Subject: WNP-2, OPERATING LICENSE NPF-21 REQUEST FOR AMENDMENT OSCILLATION POWER RANGE MONITOR TECHNICAL SPECIFICATIONS

# REQUEST FOR AMENDMENT OPRM TECHNICAL SPECIFICATIONS Attachment 1

#### **Discussion of the Proposed Changes**

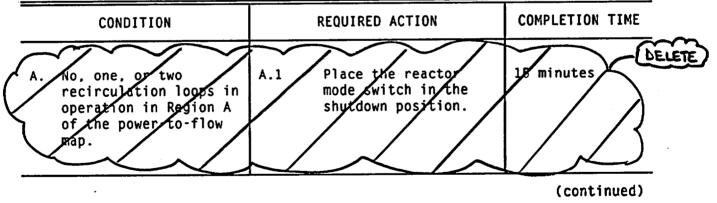
4.1.3 The description of the enabled region in SR 3.3.1.3.5 was changed from " $\geq$  30% RTP and recirculation drive flow < 60% of rated recirculation drive flow," to " $\geq$  30% RTP and core flow  $\leq$  60% rated core flow." As discussed in Section 3.2.3 of this attachment, the exclusion region methodology (safety analyses contained in NEDO-31960) defines a curved region on the power-to-flow operating map cutting across the corner of the map near the intersection of the natural circulation line and the highest flow control line. The proximity of the line to the corner depends upon plant-specific stability characteristics. To ease implementation of the reactor long-term stability solution in the WNP-2 design, conservative, squared off boundaries at 30% rated power and 60% rated core flow are specified. This is consistent with the boundaries discussed in NEDO-32465, Section 2.2, "Licensing Compliance," which states, "The trip function will be enabled when both the power level is greater than 30% of rated power and the core flow is less than 60%."

SURVEILLANCE	FREQUENCY
SR	3.3.1.3.2	Calibrate the local power range monitors.	1000 MWD/T average core exposure
SR	3.3.1.3.3	Neutron detectors are excluded.	
		Perform CHANNEL CALIBRATION.	24 months
SR	3.3.1.3.4	Perform LOGIC SYSTEM FUNCTIONAL TEST.	24 months
SR	3.3.1.3.5	Verify OPRM is not bypassed when THERMAL POWER is $\geq$ 30% RTP and core flow $\leq$ 60% rated core flow.	24 months
SR	3.3.1.3.6	Neutron detectors are excluded.	
		Verify the RPS RESPONSE TIME is within limits.	24 months on a STAGGERED TEST BASIS

Recirculation Loops Operating 3.4.1

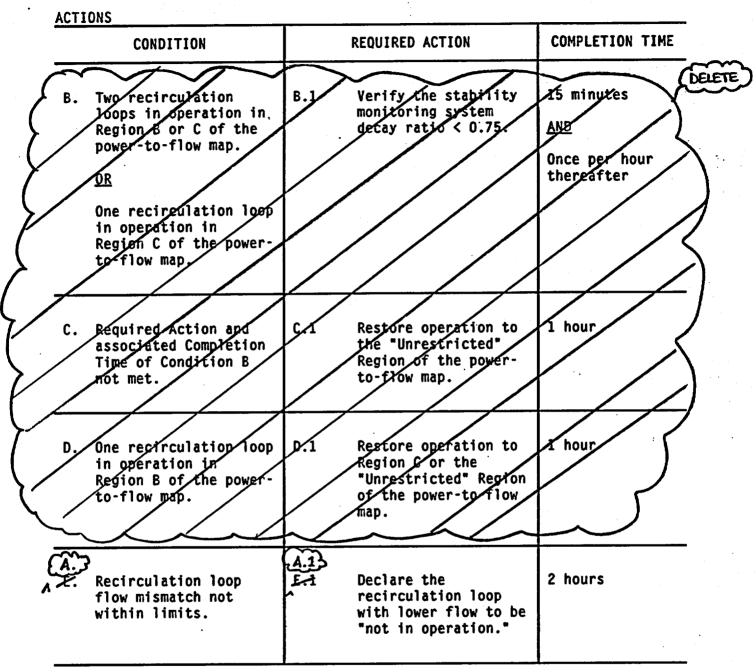
- 4.2.6 Condition E and associated Required Action E.1 of Technical Specification 3.4.1 are renamed as Condition A and Required Action A.1 respectively. This change is made to reflect the deletion of Conditions A through D of Technical Specification 3.4.1.

- 4.2.7 Condition F and associated Required Action F.1 of Technical Specification 3.4.1 are renamed as Condition B and Required Action B.1 respectively. In addition, references to Conditions B, C, D and E are deleted. This change is made to reflect the deletion of Conditions A through D of Technical Specification 3.4.1.

- 4.2.8 Condition G and associated Required Action G.1 of Technical Specification 3.4.1 are renamed as Condition C and Required Action C.1 respectively. This change is made to reflect the deletion of Conditions A through D of Technical Specification 3.4.1. In addition, reference to the power-to-flow map is removed because the reference is no longer applicable.

- DELETE Two recirculation loops with matched flows shall be in LCO 3.4.1 operation. in the Unrestricted map specified in the COLR. Region of the OR (provided that DELET Ope recirculation loop shall be in operation in "Unrestricted" Region of the power to riow man the CULR with the following limits, applied when associated LCO is applicable: LCO 3.2.1. "AVERAGE PLANAR LINEAR HEAT GENERATION RATE a. (APLHGR)," single loop operation limits specified in the COLR: and
  - b. LCO 3.2.2, "MINIMUM CRITICAL POWER RATIO (MCPR)," single loop operation limits specified in the COLR.
